# MISSISSIPPI POWER & LIGHT COMPANY

SUBJECT: Grand Gulf Nuclear Station  
Units 1 and 2  
Docket Nos. 50-416 and ~~50-417~~  
License No. NPF-13  
File: 0260/C-197.0/L-334.0  
Transmittal of Responses to  
Informal NRC-SEB Concerns on the  
Containment SIT  
AECM-83/0669

PRIMARY CONTAINMENT  
STRUCTURAL INTEGRITY TEST REPORT

Figure 3.8-1

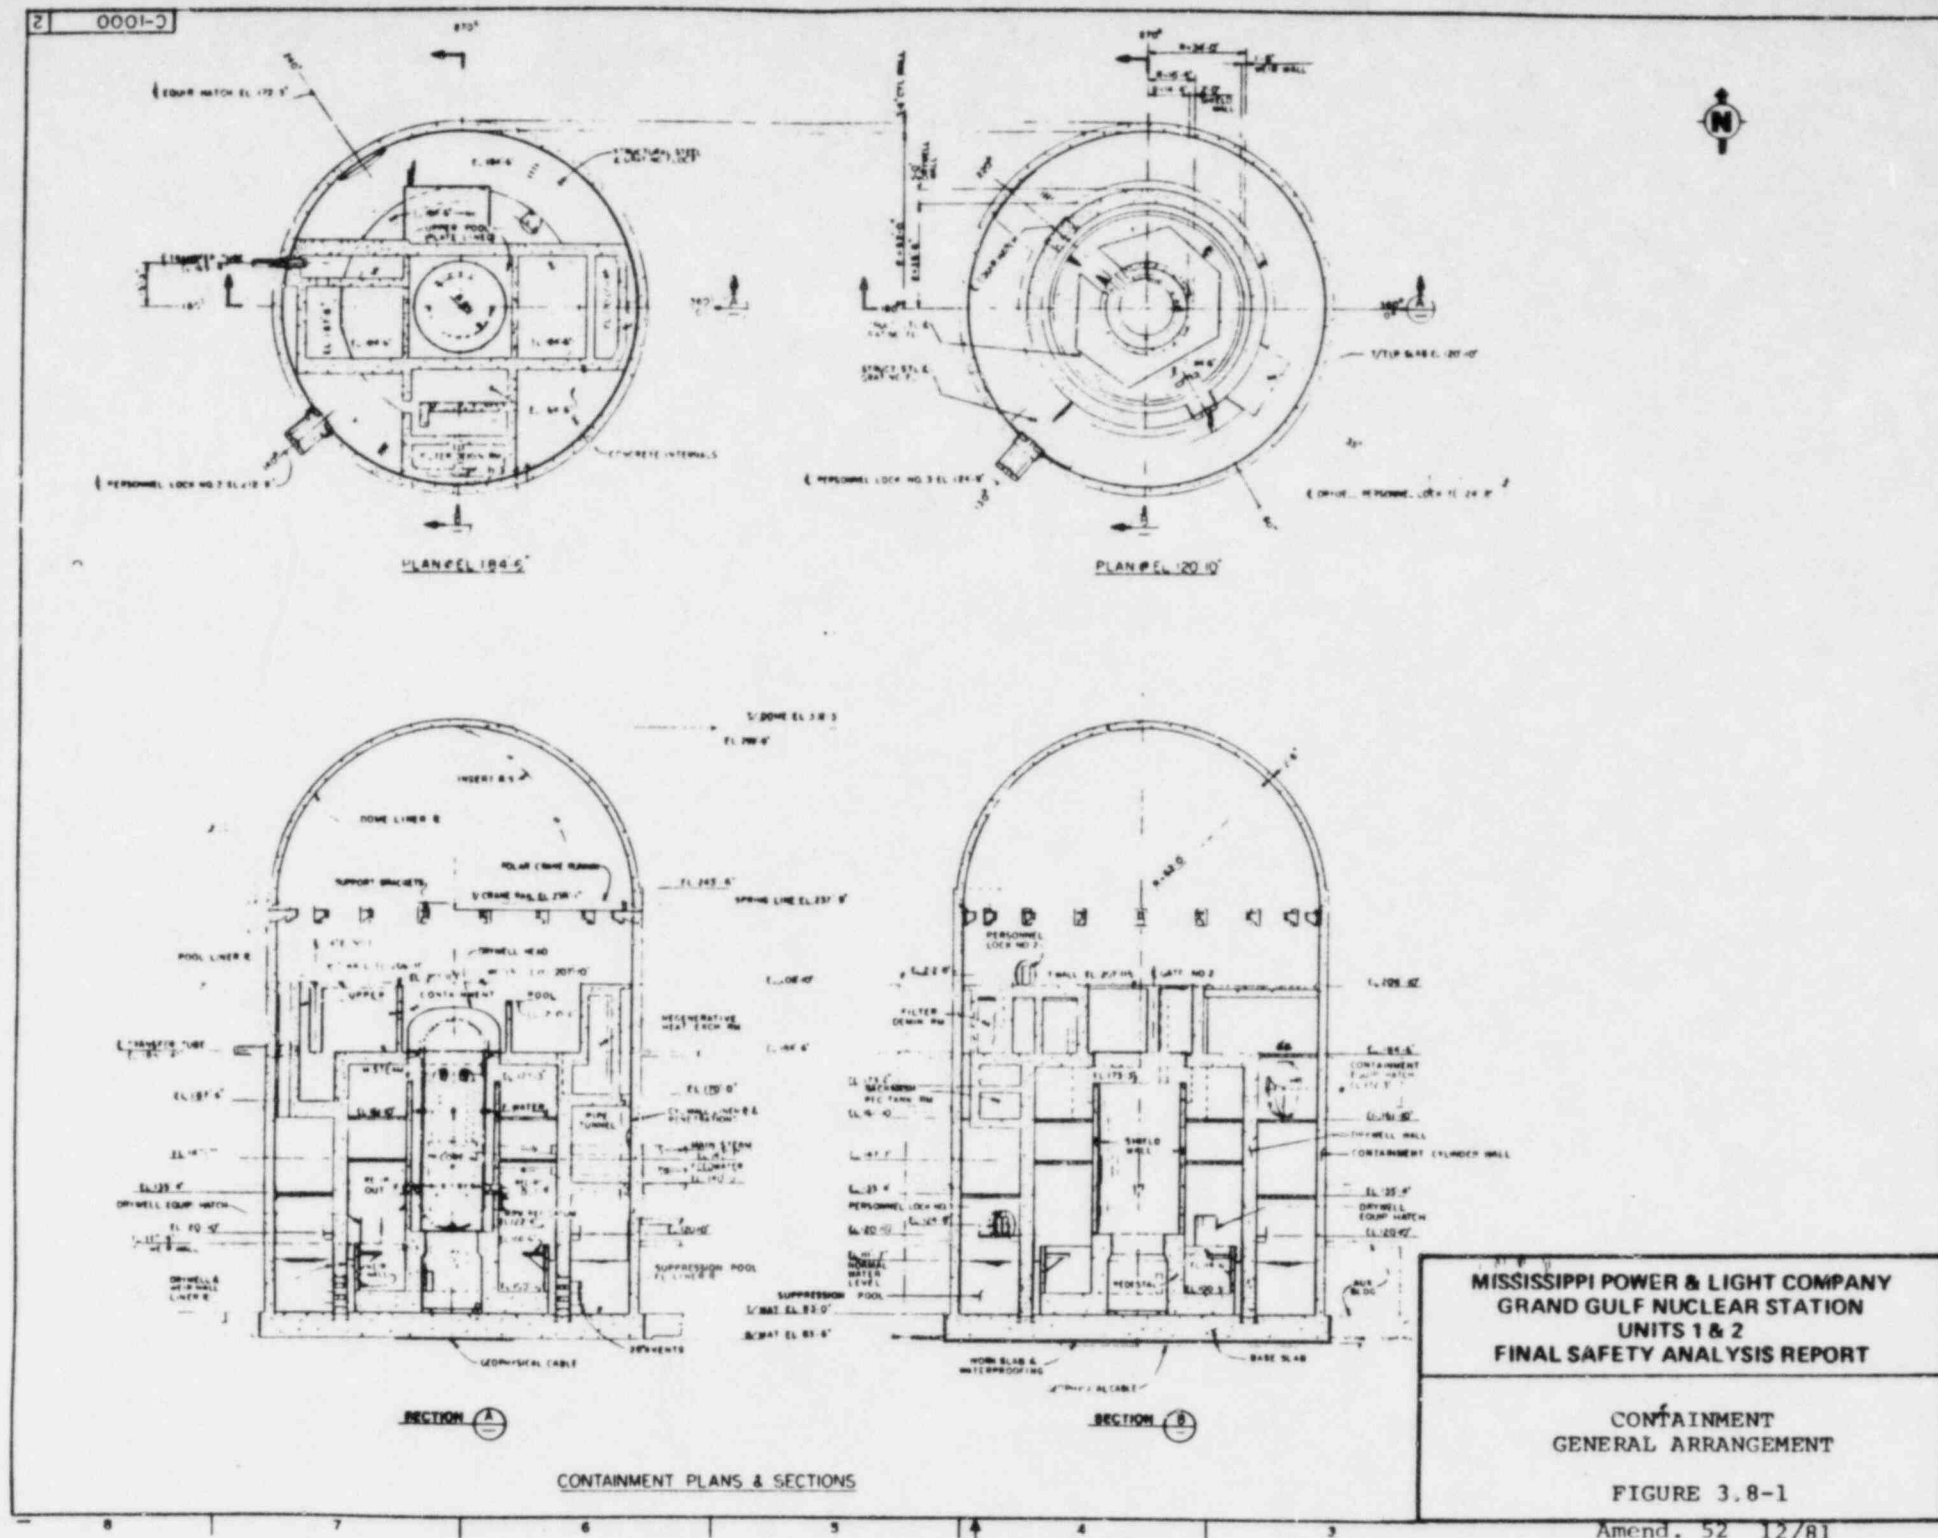
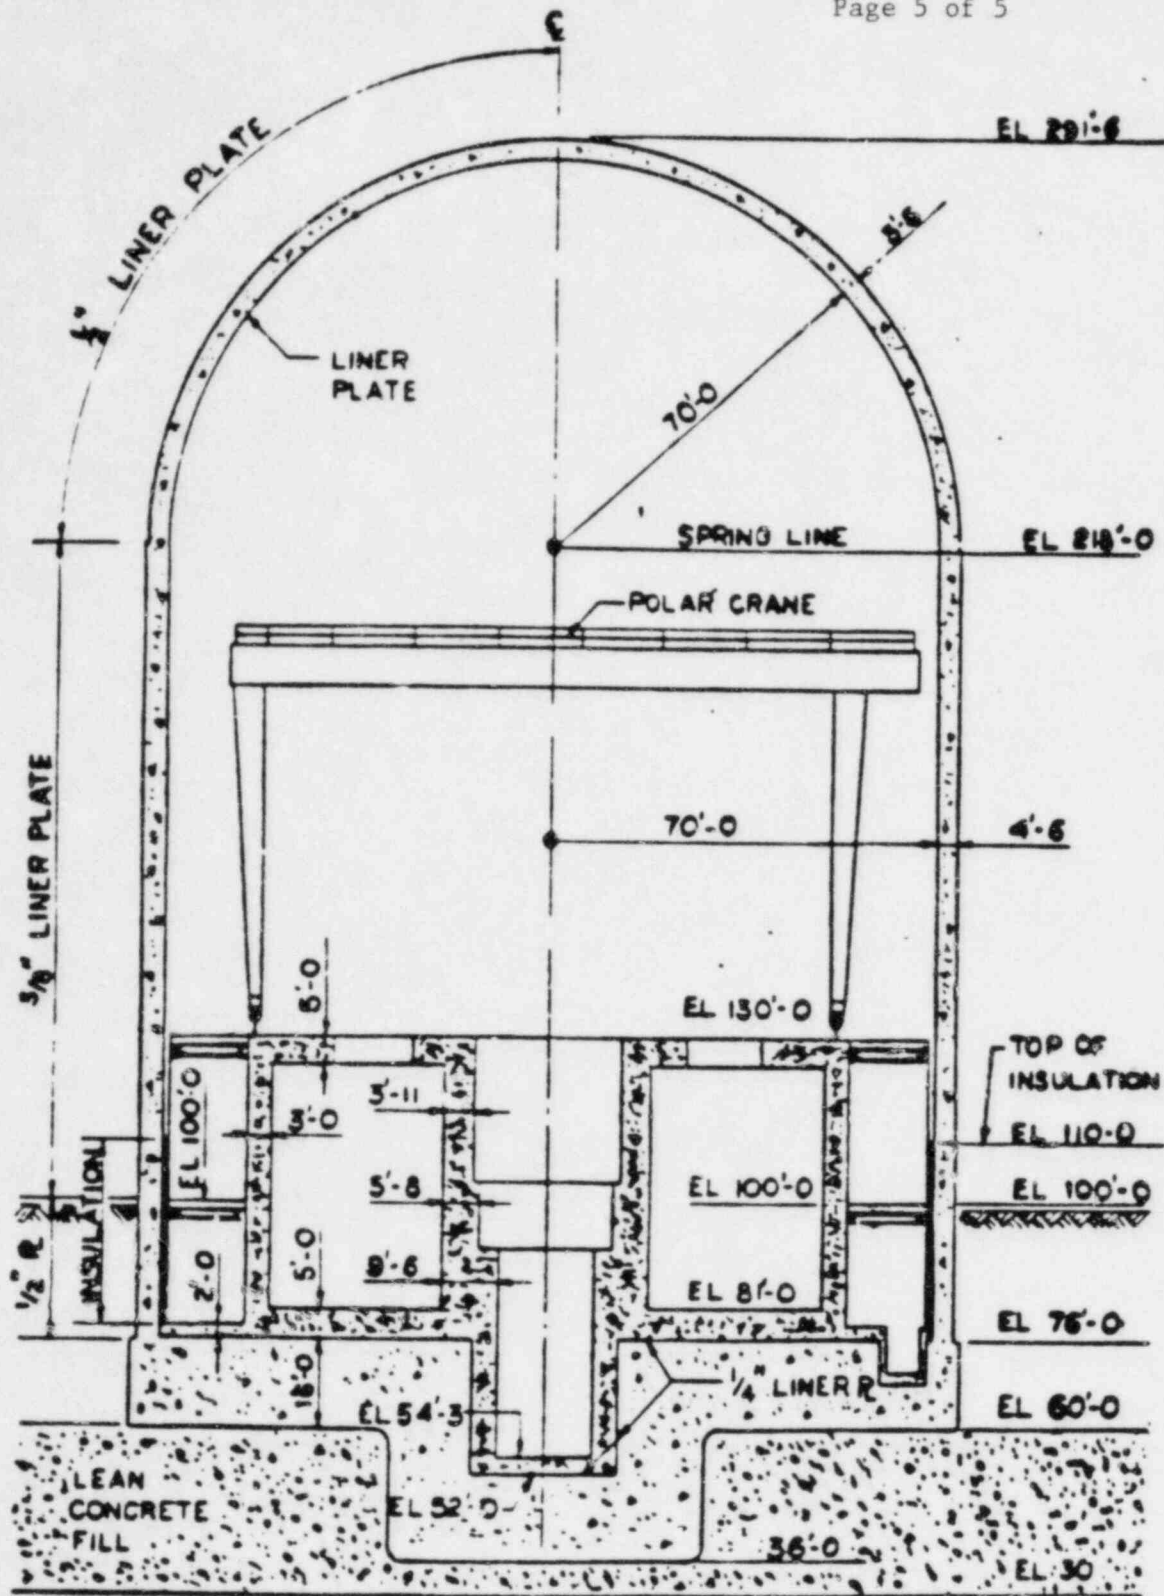
The FSAR states in subsection 3.8.1.7.1 that the containment SIT test procedure will be based on the containment being a nonprototype structure. Provide a comparison of the Grand Gulf containment design to similar containments.

The Salem Nuclear Generating Station, Unit 1, is a prototype conventionally reinforced concrete containment similar to GGNS. Its containment consists of a flat concrete base mat at the wall to mat interface, right circular cylinder, and hemispherical dome with major dimensions as shown in Salem FSAR Figure 3.8-1 (attached). The inside diameter (D) of the circular cylinder is 140 feet. The largest opening is the 19 foot diameter (0.136D) equipment hatch. No openings exceed 0.15D. Sliding or hinged joints are not used to connect the cylinder wall to the bottom slab or the dome. No intermediate interior floors are fixed to the wall. The main reinforcing in the wall consists of inside and outside layers of hoop reinforcement, inside and outside vertical reinforcement, and diagonal reinforcement placed in two directions to form a helix with an angle of approximately 45 degrees from the vertical axis of the shell. The Salem SIT is in accordance with the prototype test requirements of Regulatory Guide 1.18, as detailed in the Salem FSAR, subsection 6.2.1.2. Strain data was obtained based on a SIT air pressure of 54 psig (115 percent of design pressure) as compared to the GGNS SIT air pressure of 17.25 psig.

As described above, the Salem design is similar to Grand Gulf. Based on this similarity in design, the successful prototype testing of Salem and the successful nonprototype testing of Grand Gulf, it can be concluded that the GGNS Unit 1 containment meets the requirements of Regulatory Guide 1.18, Revision 1, for SIT testing.

FIGURE 5-1  
CONTAINMENT STRUCTURE AVERAGE DEFLECTIONS AT  
17.25 PSIG - WALL AND DOME

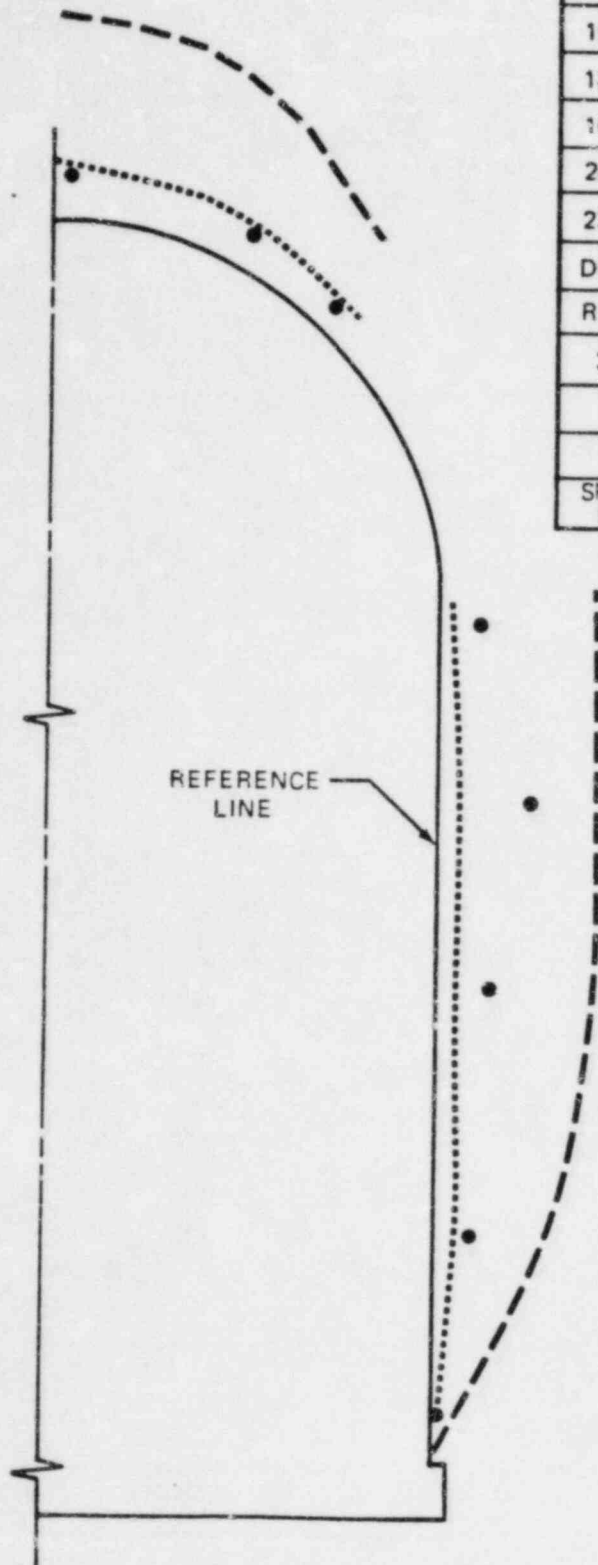
Table 4-1, "Extensometer Locations," of the Grand Gulf Nuclear Station (GGNS) Unit 1 Primary Containment Structural Integrity Test (SIT) Report, issued in January 1982, shows extensometers H-13, H-14, and H-15 at azimuths 210°, 270°, and 150°, respectively, at El. 230'-0". The table also shows that six extensometers were located at both El. 103'-0" and El. 167'-0". However, Section C.2 of Regulatory Guide 1.18, Revision 1, "Structural Acceptance Test for Concrete Primary Reactor Containments," requires that radial deflections be measured at three points along six meridians. The containment SIT performed does not meet this criteria since El. 230'-0" only measured radial deflections at three meridians.

The test method at El. 230'-0" used to measure radial deflections consisted of placing extensometers at azimuths 210°, 270°, and 150° and connecting them to their "fixed" reference points at azimuths 30°, 90°, and 330°, respectively. The azimuth diametrically opposed to the extensometer location was used as the reference point because there are no internal structures suitable for use as reference points at this elevation. The radial displacement at each azimuth was assumed to be equal to one-half of the measured change in diameter. Therefore, the displacements at azimuths 30° and 210°, 90° and 270°, and 150° and 330° are one-half of the measured differential displacements between each respective pair of azimuths. Tables 4-1, 5-13, 5-14, and 5-15 and Figure 5-1 of the GGNS Unit 1 containment SIT report have been revised to clarify the measurement locations and test results. The revised pages are attached.

1. PREDICTED DISPLACEMENT FROM CRACKED ANALYSIS.
2. PREDICTED DISPLACEMENT FROM ELASTIC ANALYSIS.
3. MIN, MAX AND AVG DEFLECTIONS AT EL. 230' ARE EQUAL TO HALF OF MEASURED DIAMETRIC DISPLACEMENTS.

FIGURE 3.8-122

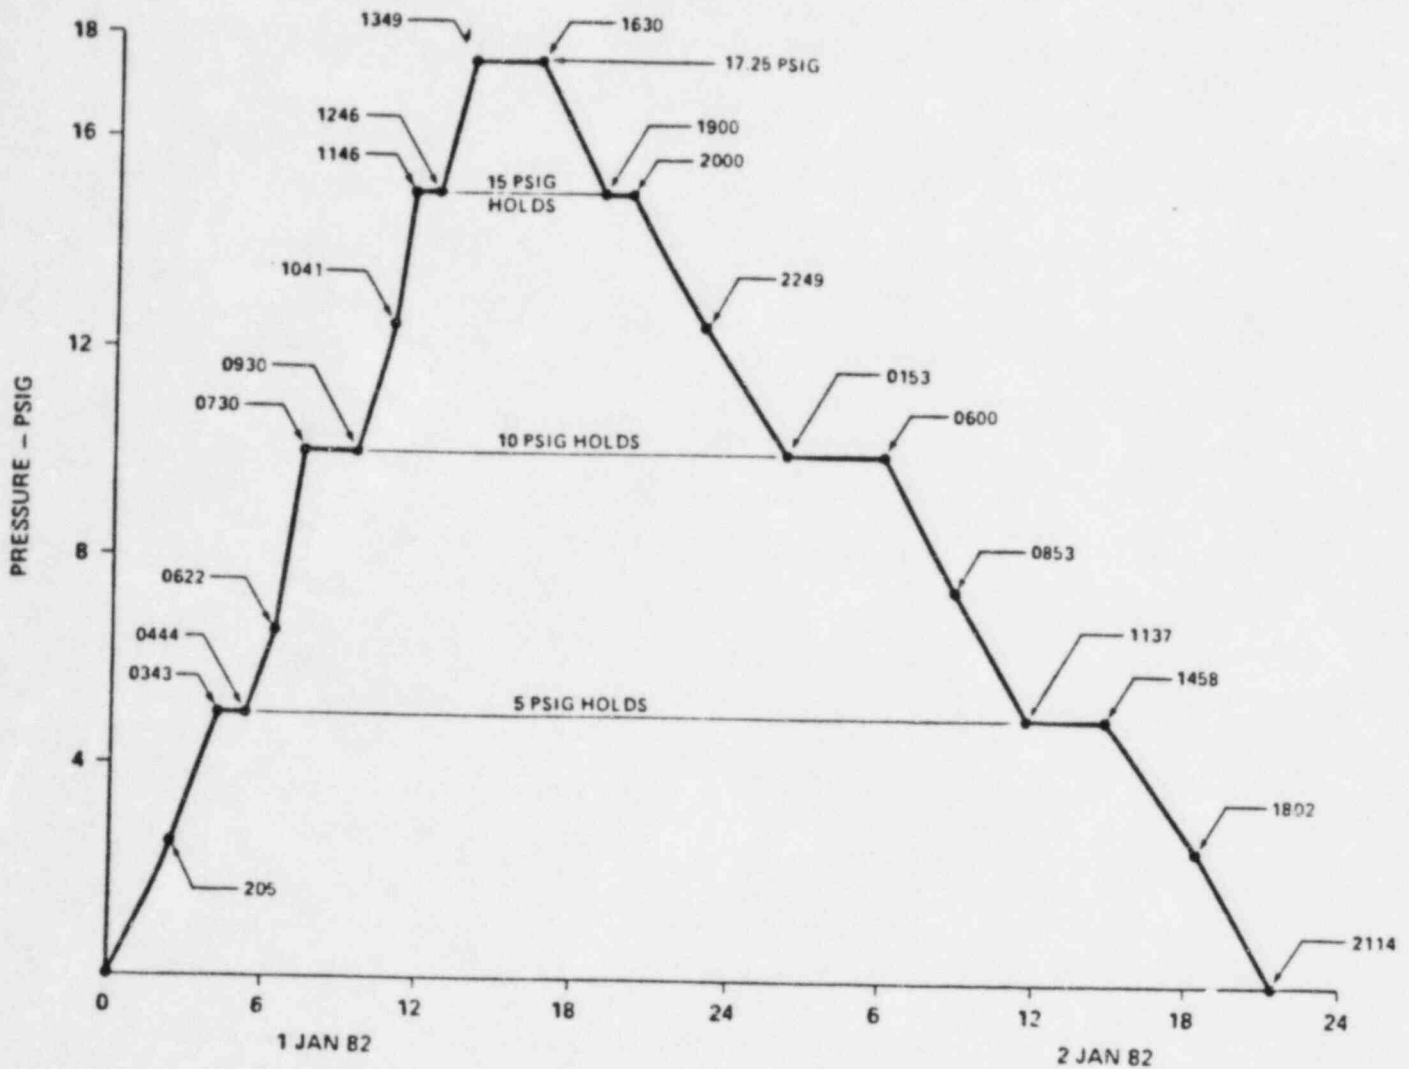
FSAR Figure 3.18-121, "Containment Structural Integrity Test Instrumentation and Crack Mapping Locations," is referenced in subsection 3.8.1.7. However, the figure was not provided in Amendment 51 to the FSAR.

Figure 3.8-121 was inadvertently omitted from Amendment 51 due to an administrative oversight. However, Figure 3.8-121 is being deleted from the FSAR. New Figures 3.8-123, 3.8-124, 3.8-125, and 3.8-126 will be added to replace Figure 3.8-121. Also, new Figure 3.8-122 was added to present the time versus pressure plot during the SIT. Additional changes to subsection 3.8.1.7 to reflect the final results of the containment SIT are also planned. A draft of these changes is attached. These changes are currently scheduled for incorporation in the FSAR in Amendment 57.
